SEUIC_Malata_D003_K4_MAIN_SCH_VER1.0

Company		SEUIC			
Title		TABLE_BLOCK			DRN BY Jason.W
Size A4	Document Number SEUIC Malata D003 K4 MAIN SCH				Rev 1.0
Date:		Friday, July 11, 2008		Sheet	1 of 11

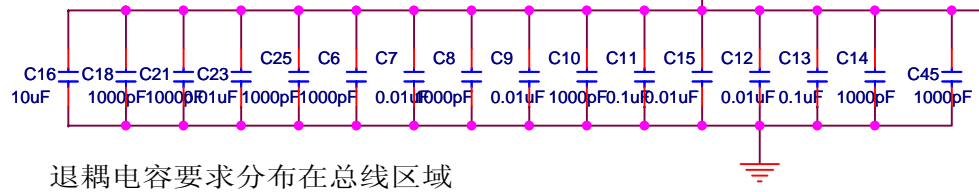
退耦电容要求分布在总线区域

Company		SEUIC	
Title		MEMORY	
Size		A3	
Document Number		SEUIC_Malata_D003_K4_MAIN_SCH	
Date:		Friday, July 11, 2008	
Sheet		5 of 11	
Rev		1.0	
DRN BY		Jason.W

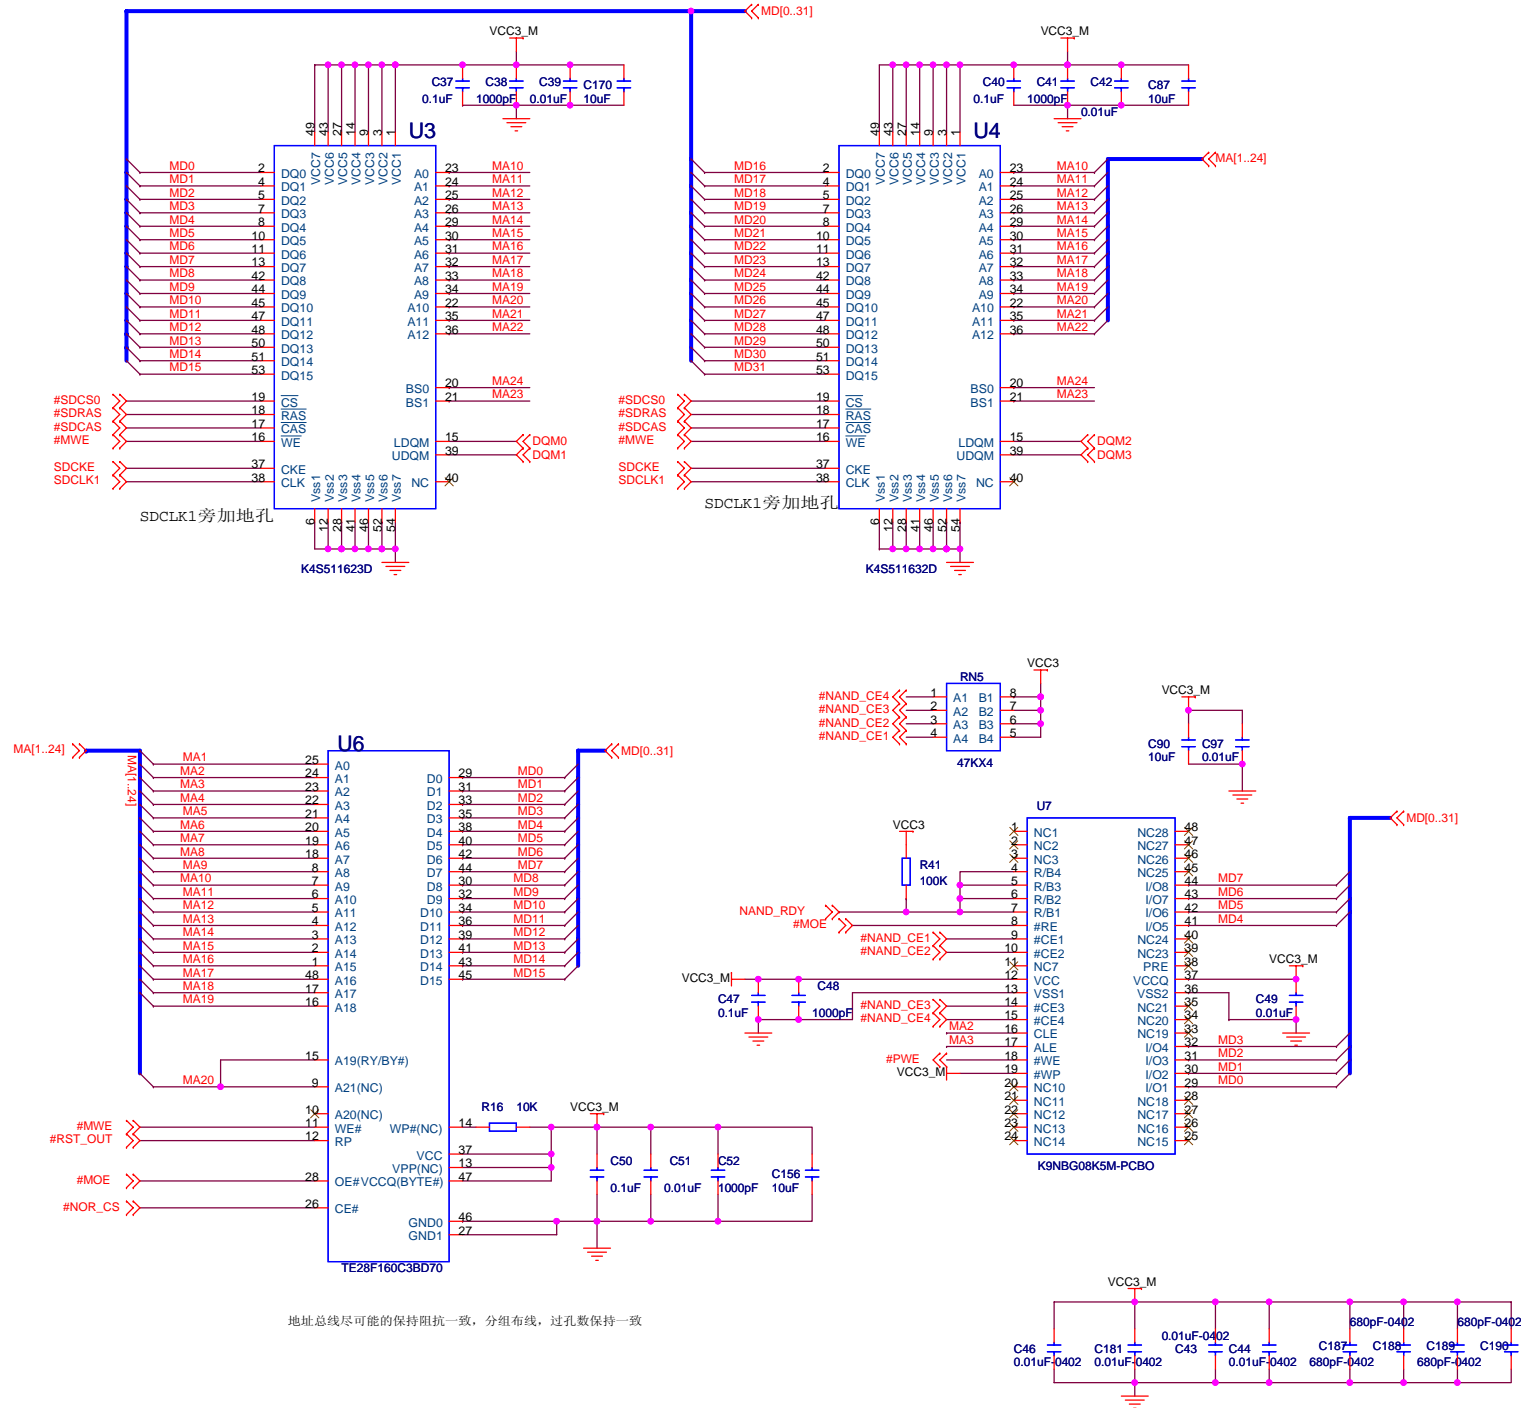
修改点:
nandflash 改成VLIO模式接法

Company		SEUIC	
Title		AUDIO_TOUCH	
Size		A3	
Document Number		SEUIC_Malata_D003_K4_MAIN_SCH	
Date:		Tuesday, November 06, 2007	
Sheet		7 of 11	
Rev		1.0

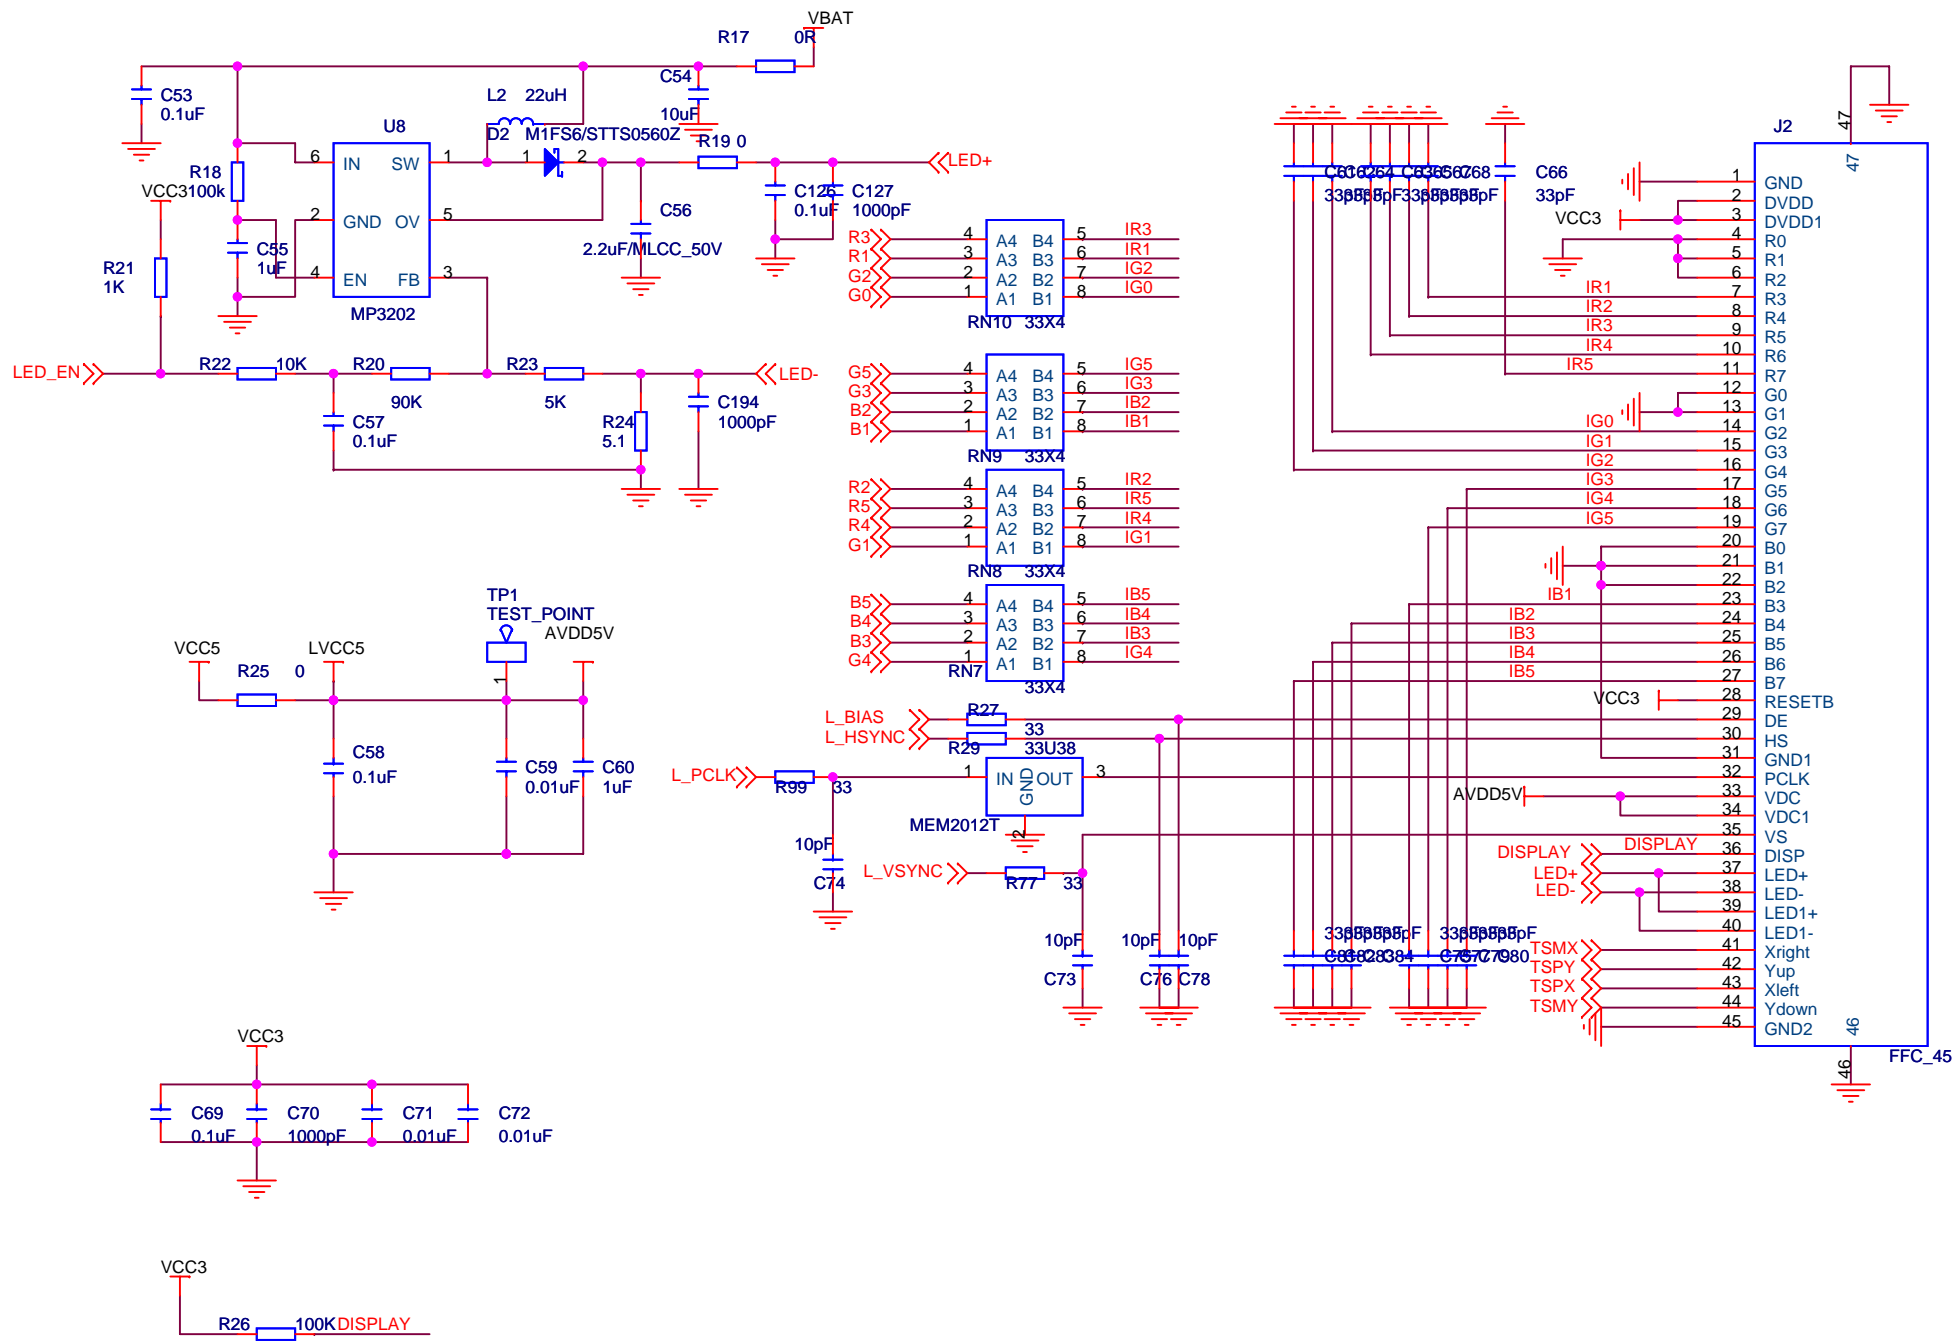
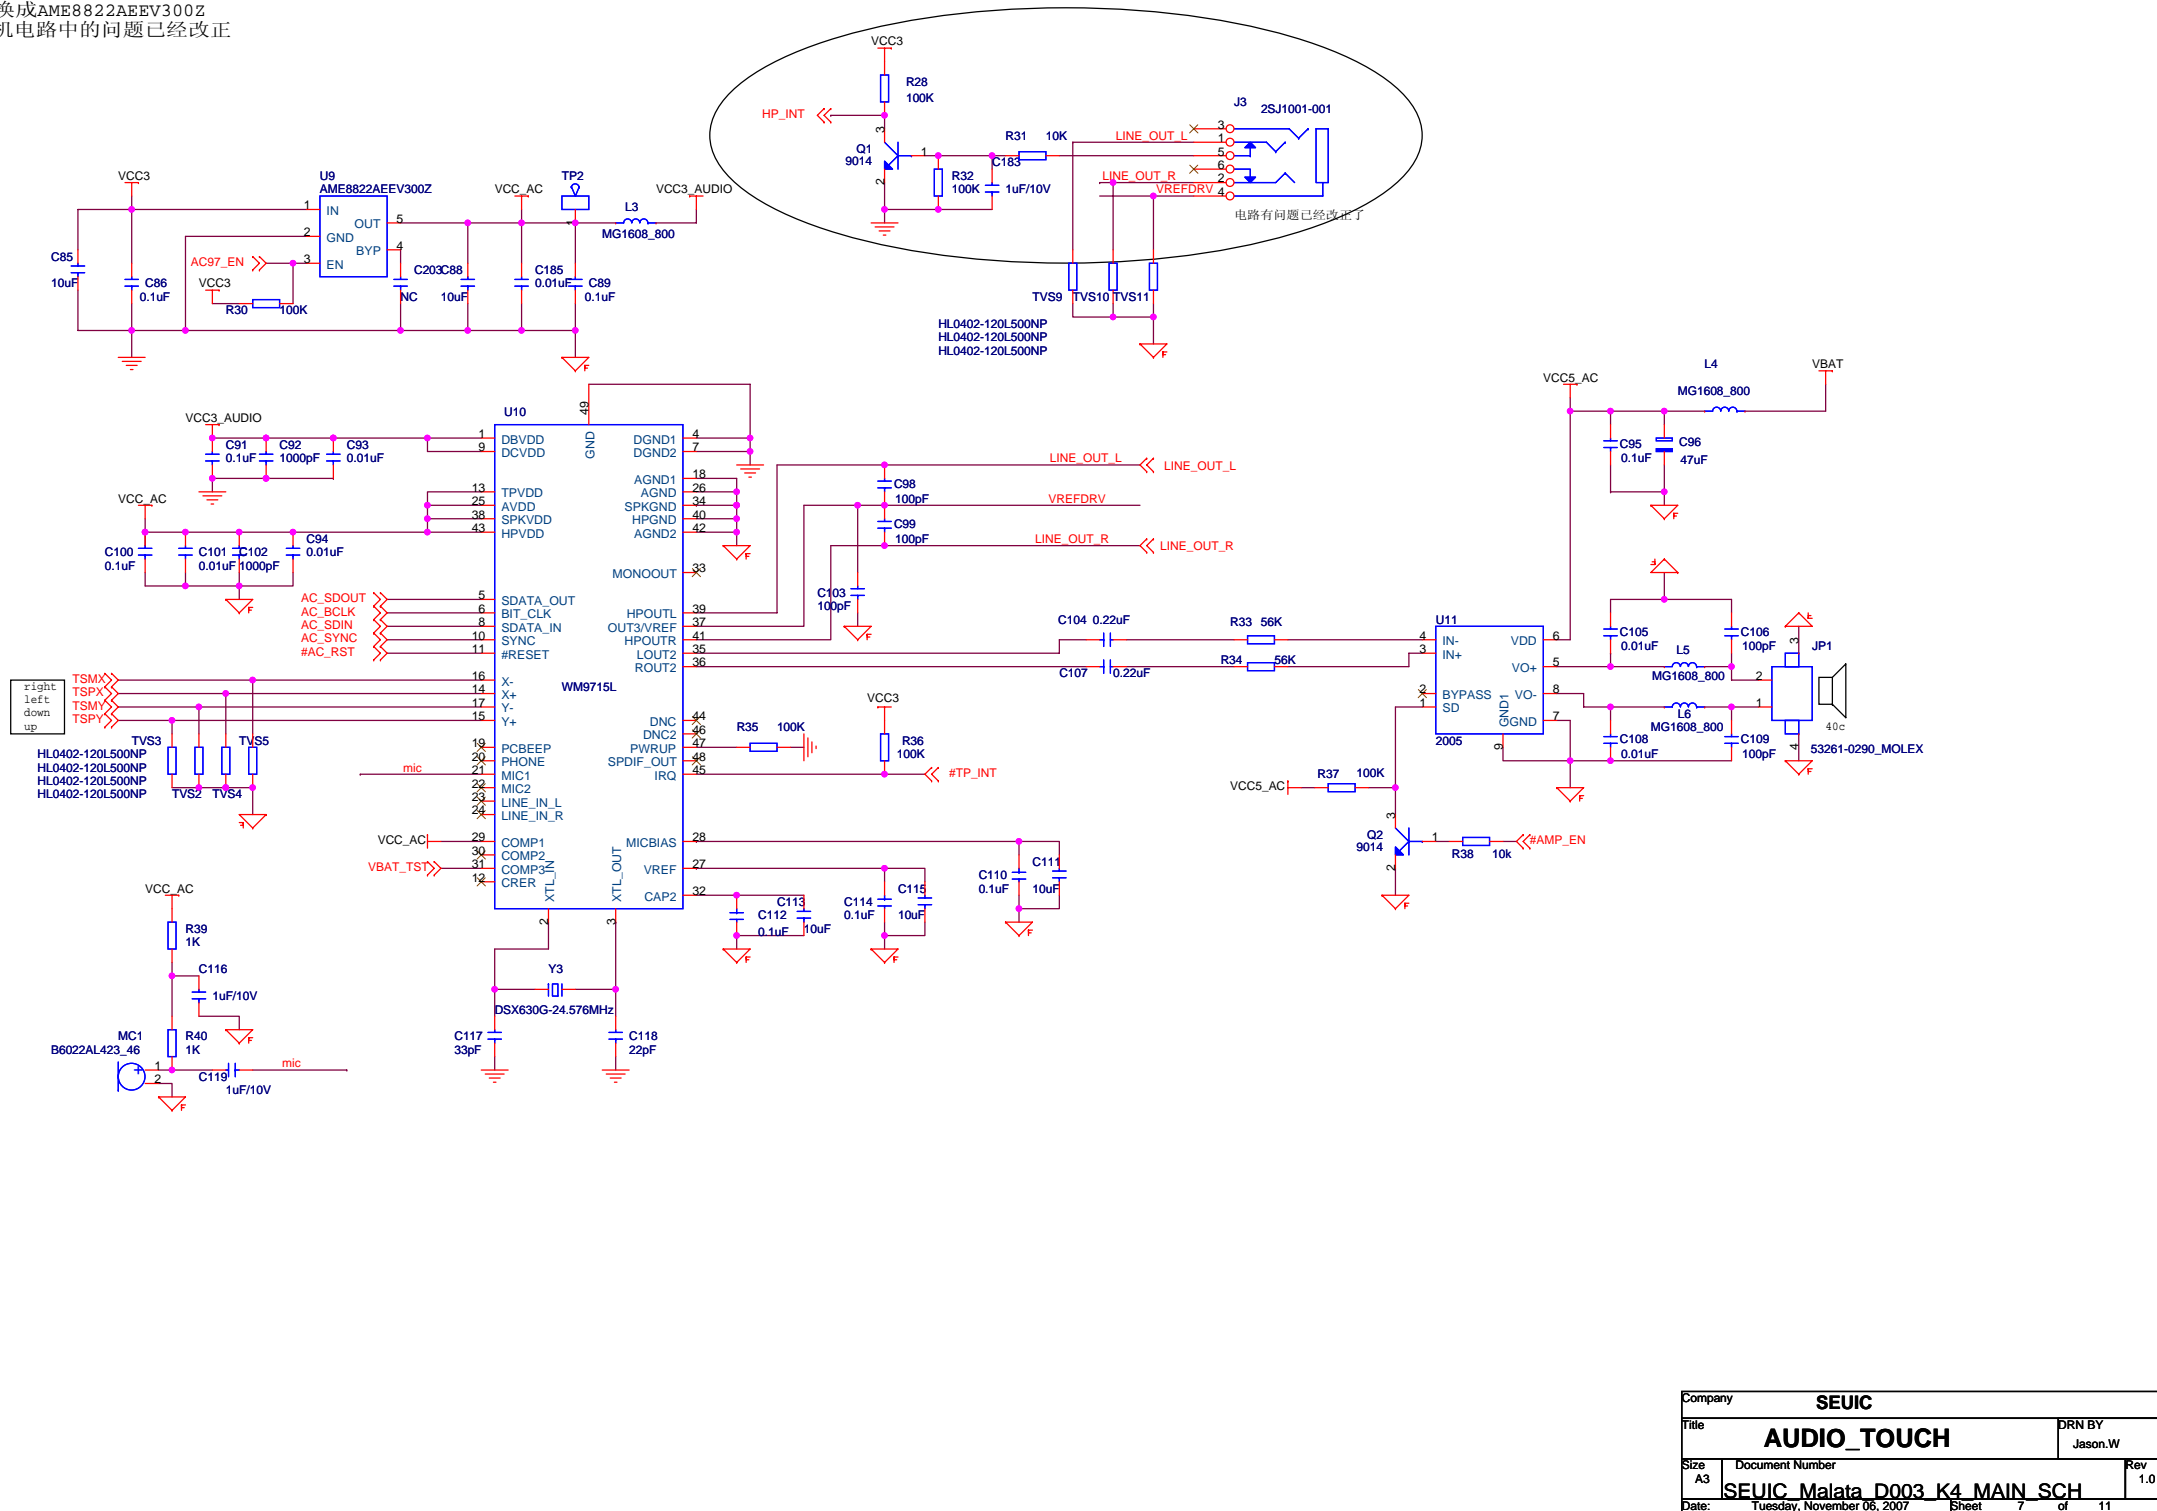
修改点:
U9换成AME8822AEEV300Z
耳机电路中的问题已经改正

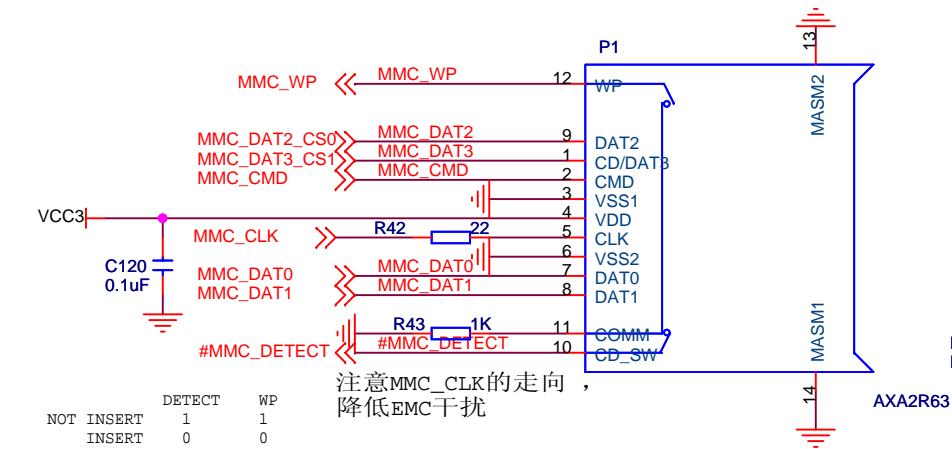
修改点：
外电插入检测电路更换，已经验正过

USB

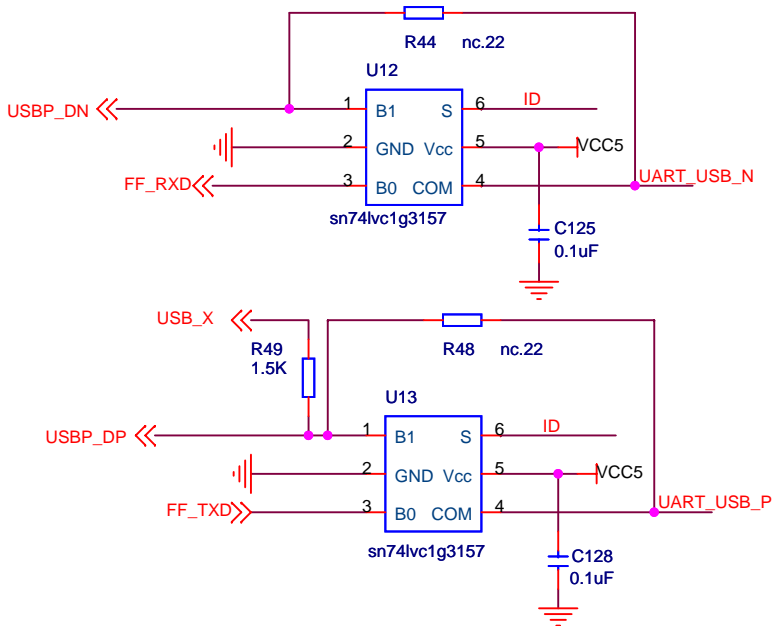
USB_N 和USB_P走成差分线

Company		SEUIC	
Title		POWER	
Size		A3	
Document Number		SEUIC_Malata_D003_K4_MAIN_SCH	
Date:		Tuesday, November 06, 2007	
Sheet		9 of 11	
Rev		1.0

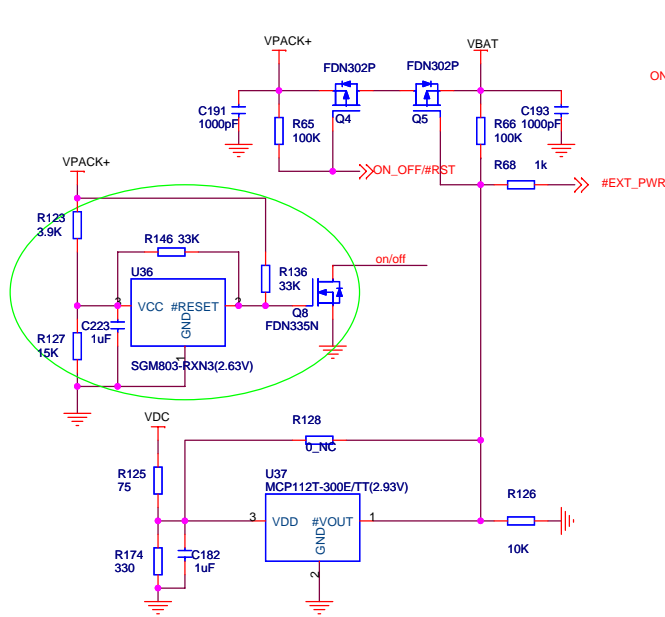
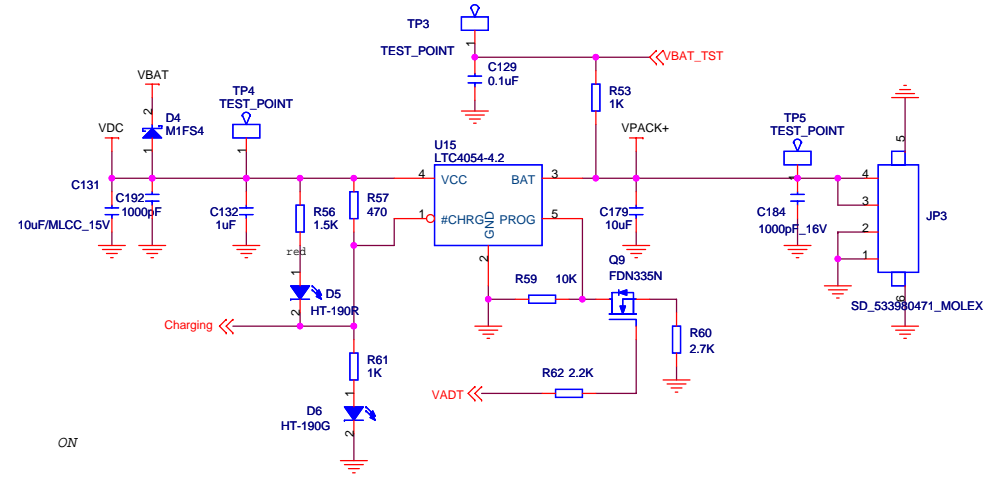
复位电路，布局时远离易发热，强数字干扰区。

Company		SEUIC	
Title			DRN BY
GPS_MODULE			Jason.W
Size	Document Number		Rev
A4	SEUIC_Malata_D003_K4_MAIN_SCH		1.0
Date:	Tuesday, November 06, 2007	Sheet	10 of 11

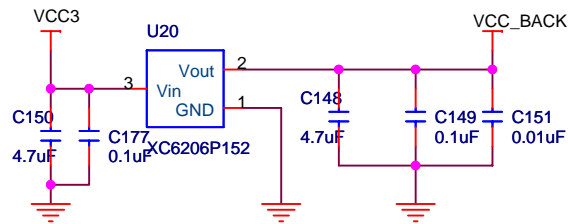
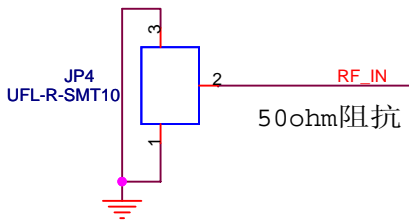
修改点：
U21换成AME8822AEEV300Z

远离vcc3,可以靠近模块放置

Company		SEUIC	
Title		FM TRANSMITTER	
		DRN BY Jason.W	
Size B	Document Number SEUIC_Malata_D003_K4_MAIN_SCH		Rev
Date:	Thursday, July 10, 2008	Sheet 11 of 11

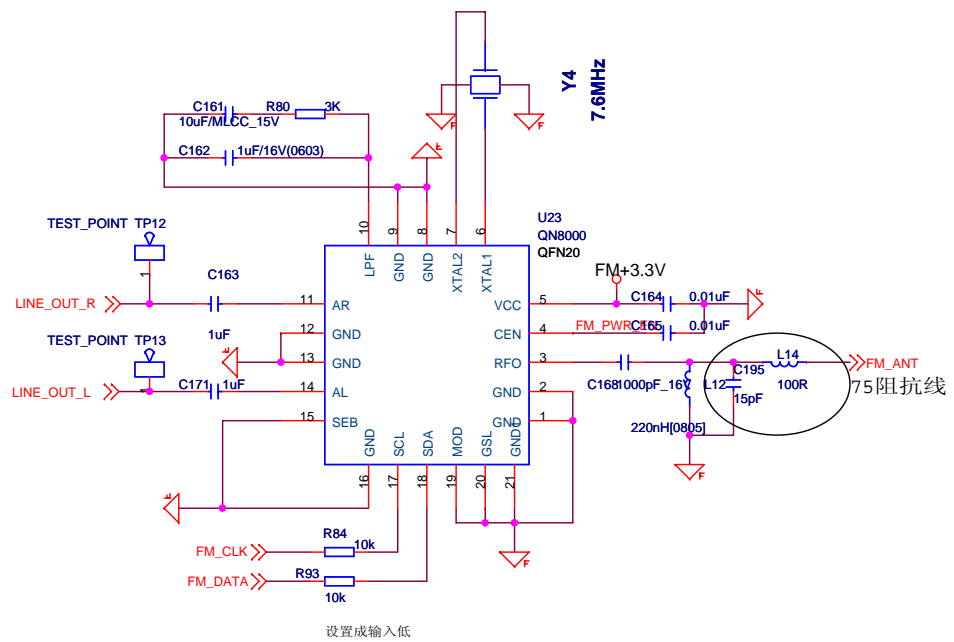
修改点：
R83和L12的位置互换
